CITY OF PORTLAND BUILDING PERMIT

PERMIT ID: 2012-65556

Proposed Use: New Hotel (Hyatt Place Portland-Old Port) 7 stories, 123 guest rooms with restaurant and retail spaces	Proposed Project Description: Foundation site work for the hotel - separate permit for rest of work in next phase
--	---

433 Fore Street - 032-I-040
#2012 558 - B-3 Zone
10/3/2012

Four Corners Method Of Calculating Average Grade

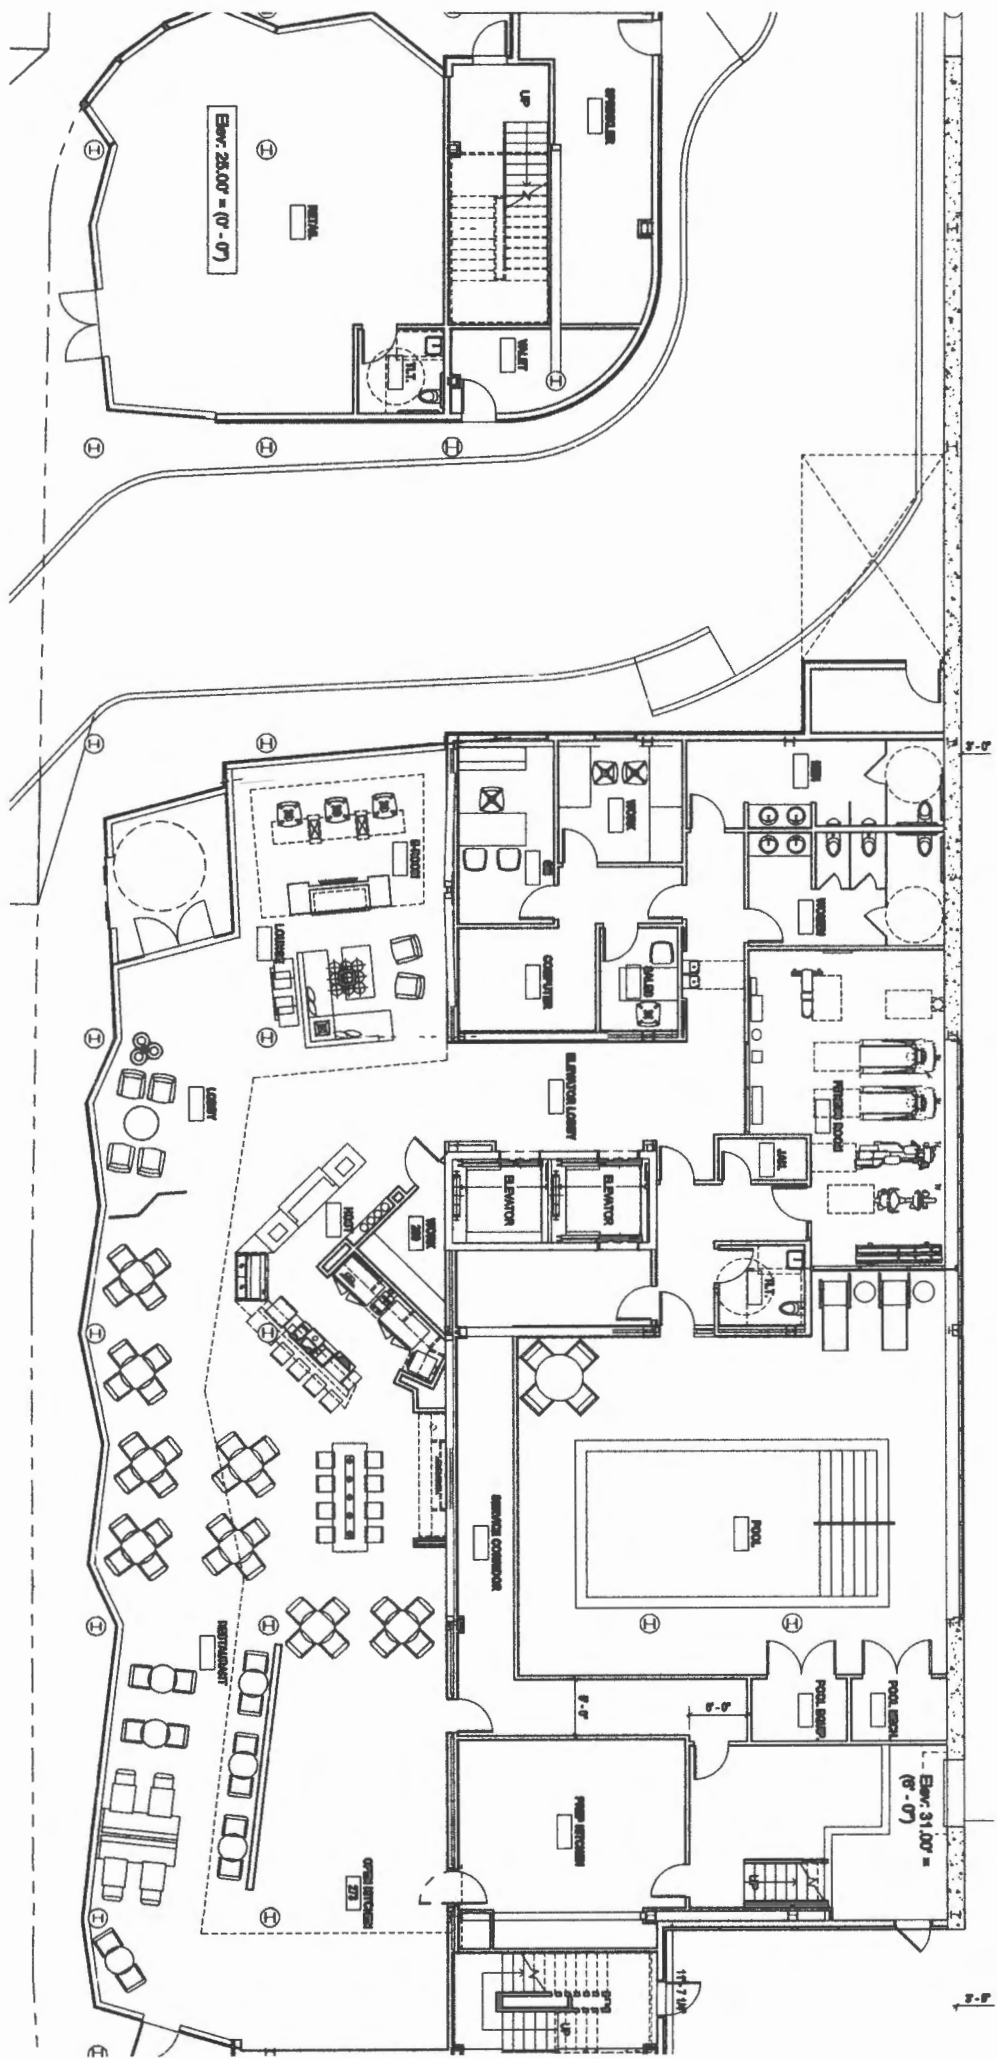
I have been able to view the most recent submission. Currently the room number count has been reduced by one to 123 rooms. I have also reviewed the elevations showing the average grade using the computation method that I commonly use. The 65' maximum street wall height is being met. The so-called kink wall is also meeting the maximum street wall height requirement. The maximum allowable height for the structure is 85' and the top of the highest roof beam is 75.25'. There is a roof wall surrounding the HVAC units and elevator shafts that is not required to meet the height requirement by Ordinance.

$$\begin{array}{r} 102.50' \\ - 27.25' \\ \hline 75.25' \\ \text{max is } 85' \end{array}$$

$$\begin{array}{r} 92.25 \\ - 27.25 \\ \hline 65.00' \end{array}$$
